# Technical Bulletin

Bulletin No: TCH-003-042

## Subject: BRAKE VALVE TREADLE REPLACEMENT – COACH APPLICATIONS

Figure 1 – Old Style Treadle

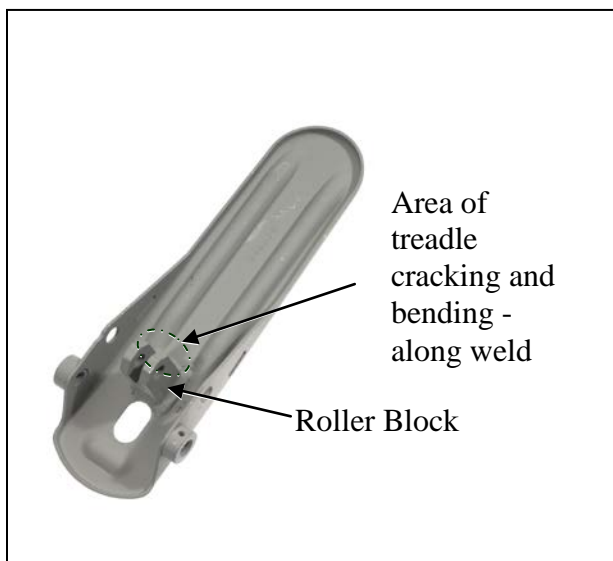
During normal use, some brake valve treadles may develop small cracks along the top surface, causing the brake valve treadle to bend. Over time this bend will result in a decreased treadle angle, which in turn will require an increase in braking effort by the vehicle operator. A quick visual inspection can identify if this condition is present.

A bump or worn spot present in the treadle cover, near the roller area, may indicate that the treadle is cracked and bent, pushing the cover up in the center. Removal of the treadle cover or inspection of the bottom side of the treadle will verify if this condition exists.

This condition is limited to coach applications with a treadle configuration as shown in Figure 1. This unique treadle has a roller block welded to the middle of its underside. The cracking occurs near this weld.

If this condition exists, the treadle assembly must be replaced with Bendix Treadle Assembly piece number **5000293**. As shown in figure 2, the new treadle does not contain a welded roller block in the center. Because of this design change, the roller and pin can not be interchanged from the old treadle assembly to the new. To facilitate installation, the treadle, treadle cover, pin, roller, cotter pin and fasteners are included with the new treadle assembly.
